Stannah Lifts Technical Bulletin

Issue No: M21 rev A Date: 11/12/2003 Page: 1 of 1

LIFT TYPE: Hydraulic passenger lift with 2 panel side opening doors

Door sill protector:

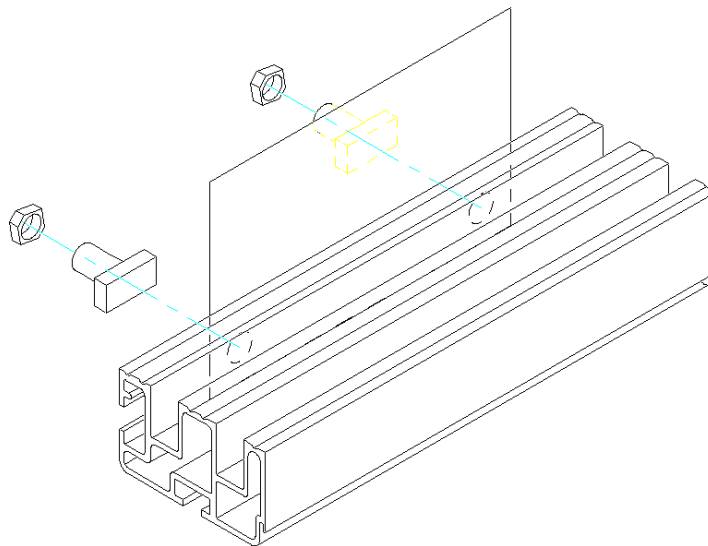
Over a period of time, installers have experienced a number of cases of builders, over building onto the landing door tracks of 2PSO landing doors. The results of this lead to installers having to waste their time clearing out the tracks. To avoid this happening Stannah lifts are now providing a door sill protector (prt number 2000440).

The door sill protector is attached to the front edge of the door track with 2 M8 halfen bolts and 2 M8 nuts (supplied). The protector acts as a physical barrier to over build, and should be positioned on the door track where over build may occur. As over build may occur in the entrance or behind the architrave, position the protector where you think there may be a problem. Slots have now been added to the design so to allow removal.
